Docket Number:	07-AFC-06C
Project Title:	Carlsbad Energy Center - Compliance
TN #:	203095
Document Title:	Responses to Data Request Set 2A (Nos. 59-66)
Description:	N/A
Filer:	Dee Hutchinson
Organization:	Locke Lord LLP
Submitter Role:	Applicant Representative
Submission Date:	9/23/2014 4:41:11 PM
Docketed Date:	9/23/2014

Re: Petition to Remove Obsolete Facilities to Support Construction and Petition to Amend
the Carlsbad Energy Center Project (07-AFC-06C)
Responses to Data Request Set 2A (Nos. 59 - 66)

Data Response Set 2A (Responses to Data Requests 59 to 66)

Figure DR60-1
Typical Detail – Temporary Tank Bottom Liner
 Amended Carlsbad Energy Center Project
 Carlsbad, California (07-AFC-06C)
 Petition to Amend

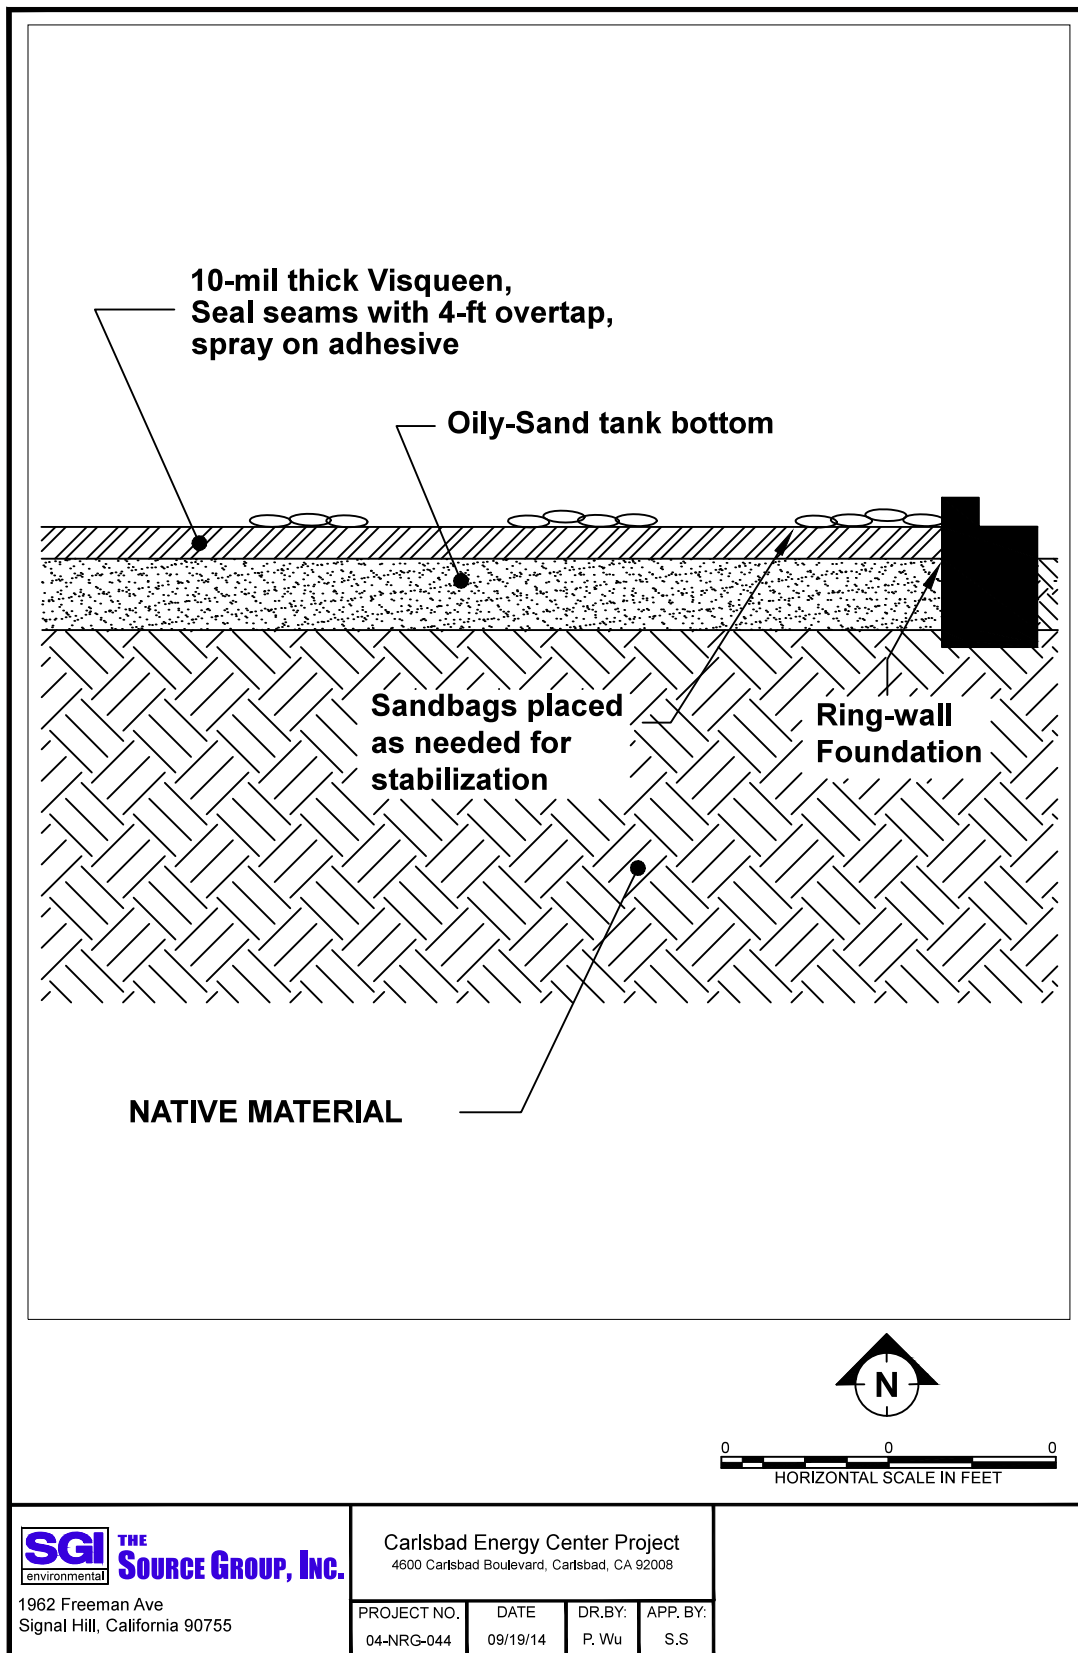
60. Please explain how the project owner would demonstrate that human health, water resources, and the environment are adequately protected once the tanks and the Encina Power Station are demolished, without a subsurface site characterization and/or soil remediation immediately following demolition of these facilities.

Response: After the ASTs are removed to grade at the facility, engineering controls will be deployed to stabilize the area in the interim period between completion of above-grade demolition and below-grade assessment and remediation. Engineering controls will consist of a temporary liner system installed as a Best Management Practice (BMP) for storm water infiltration and runoff mitigation. The BMPs will be implemented per the attached drawing (Figure DR 60-1 Typical Detail – Temporary Tank Bottom Liner). Other potential remedial areas associated with the EPS main power block and ancillary equipment will be protected by leaving ground-level foundations in place. The DEH does not allow ground disturbance prior to DEH approval and characterization. Therefore, a subsurface site characterization appropriate for the future redevelopment and land use of the EPS property will be conducted immediately prior to a subsequent landowner’s future demolition of any of the ground level foundation.
